DOMUSEA DEVELOPMENTS
PROPOSED RESIDENTIAL DEVELOPMENT
THE BOWERIES, BARNHAM ROAD,
EASTERGATE

STAGE 1 - ROAD SAFETY AUDIT

OCTOBER 2019

scale 1:250 @ A3 date OCTOBER 2019 drawing number MBSK191001-01	title VISIBILITY SPLAYS AT ACCESS	client DOMUSEA DEVELOPMENTS project THE BOWERIES, BARNHAM ROAD EASTERGATE	drawn by JME checked by AP cad file FIGURES A.DWG rev. D
---	-----------------------------------	---	---

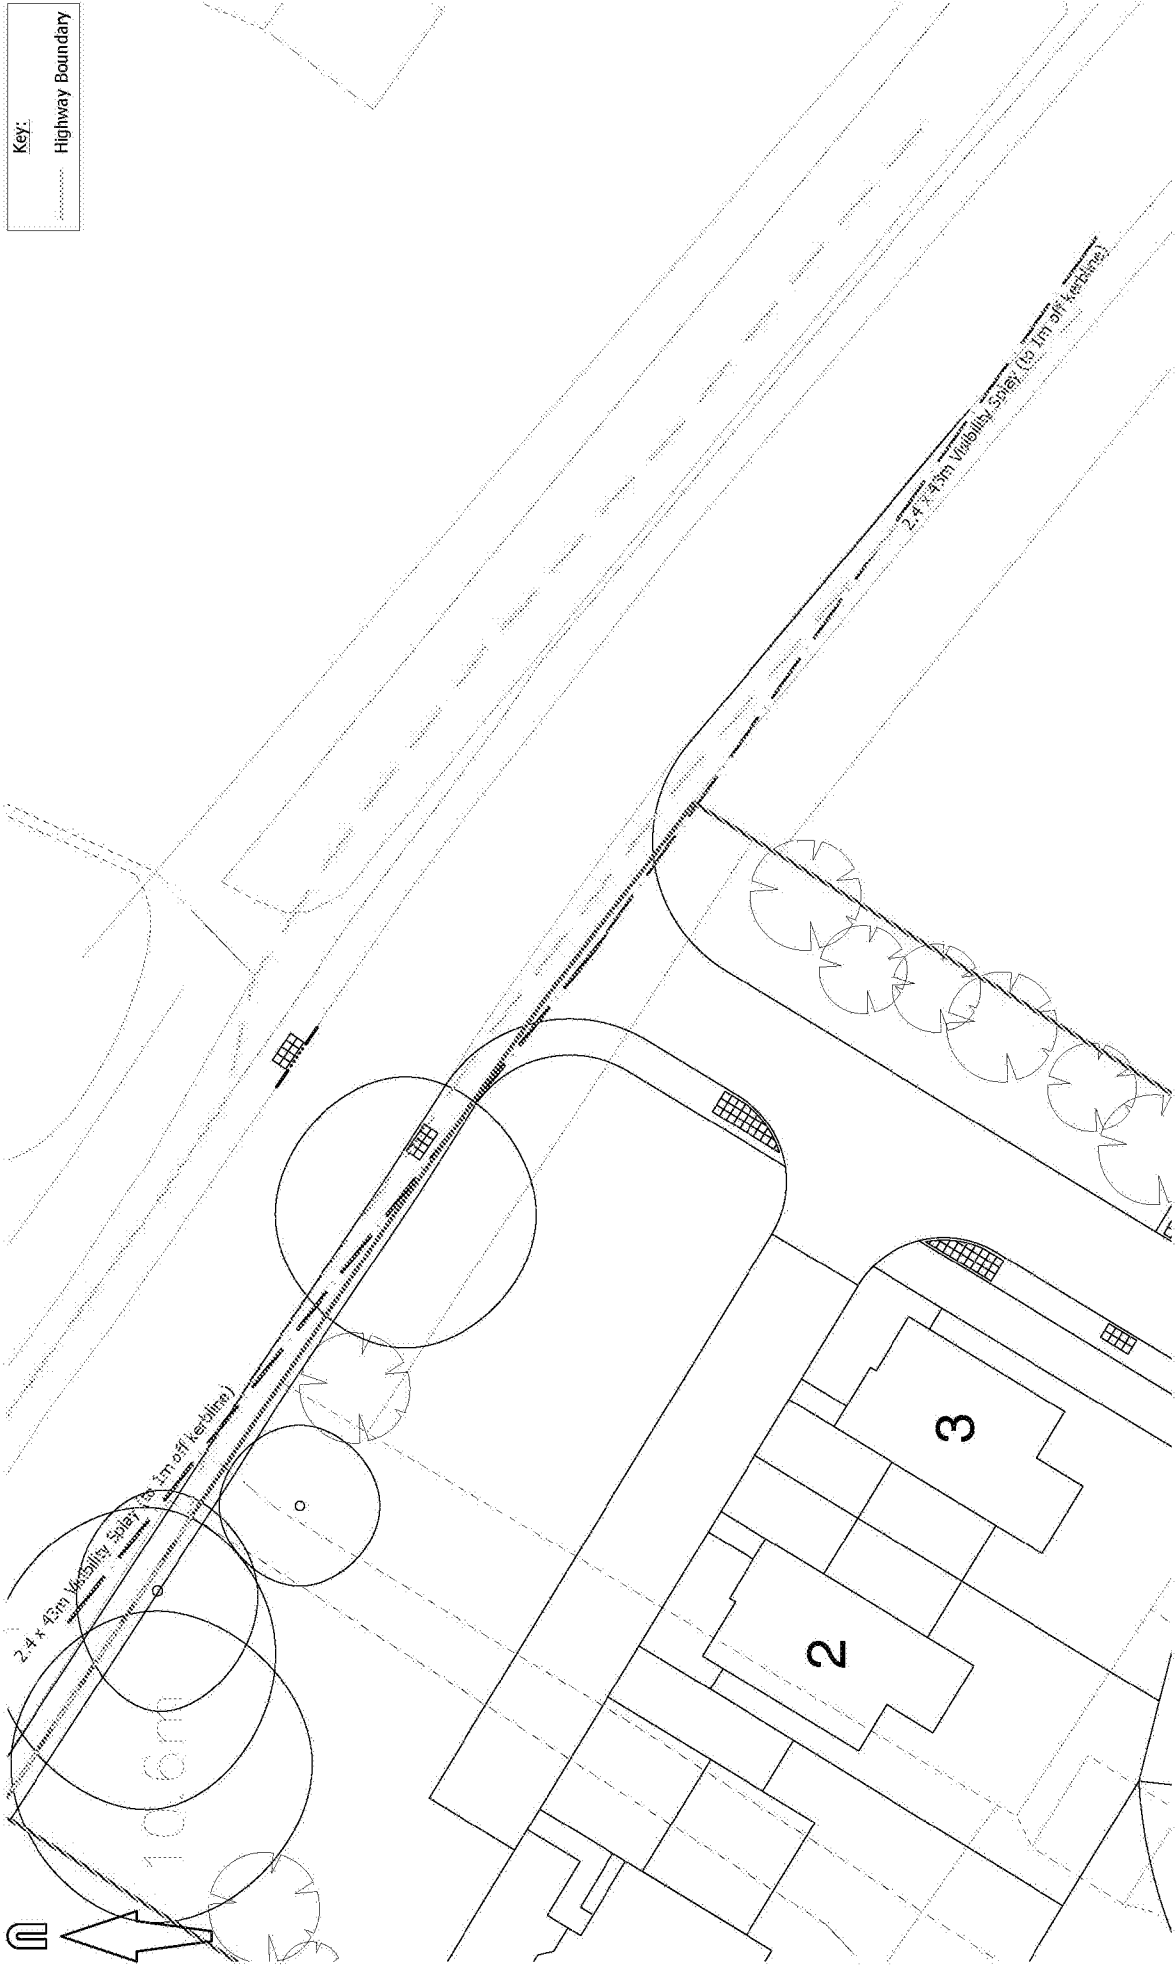
Location: Site Access

Summary: Obstruction to visibility splays

Junction visibility splays have been formally identified on the drawings provided for Audit. It will be important that any vegetation within these splays is trimmed/maintained to ensure that the visibility splays remain unobstructed.

- i. Any vegetation within the splays should be trimmed/maintained.
- ii. Vegetation within the splays should not extend beyond a vertical height of 0.6m.
